## PIC24FJ128GA310 Family Silicon Errata and Data Sheet Clarification

The PIC24FJ128GA310 family devices that you have received conform functionally to the current Device Data Sheet (DS30009996G), except for the anomalies described in this document.

The following typographic corrections and clarifications are to be noted for the latest version of the device data sheet (DS30009996G):

### 64-Lead Plastic Quad Flat, No Lead Package (MR) – 9x9x0.9 mm Body with 5.40 x 5.40 Exposed Pad [QFN]

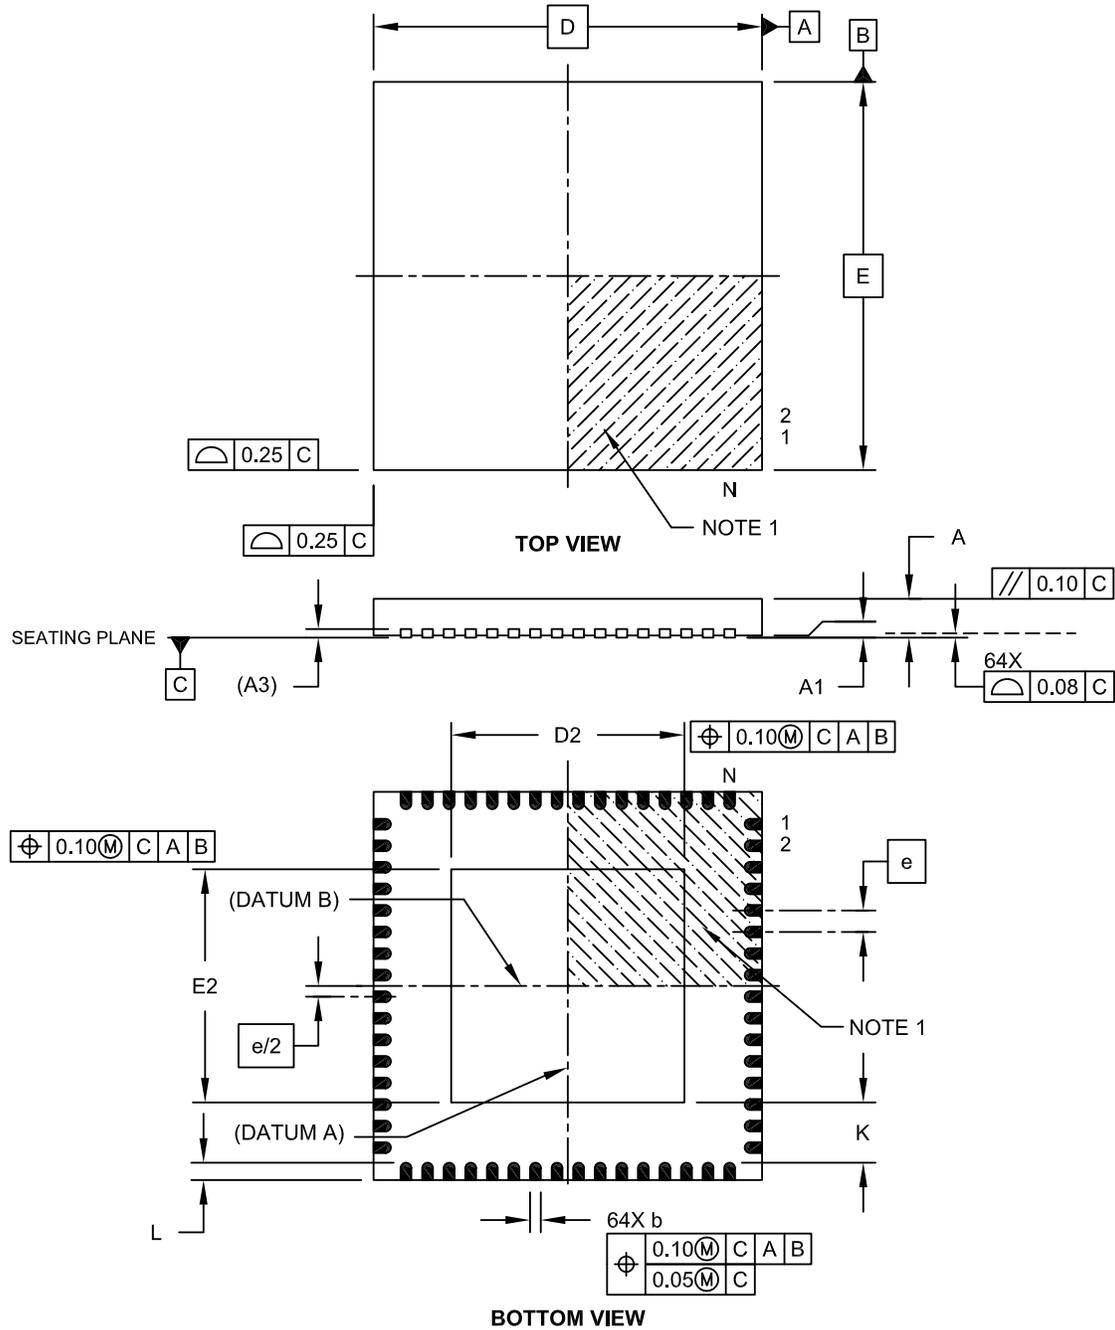
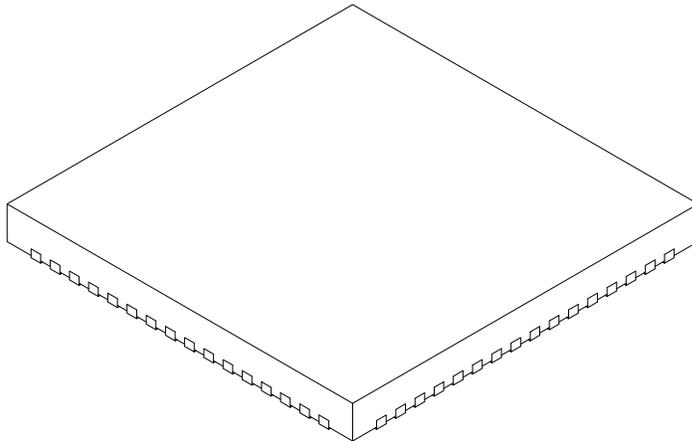
The 64-Lead Plastic Quad Flat, No Lead Package (MR) drawings on Pages 391 through 393 have been replaced with the C04-154A package drawings shown below.
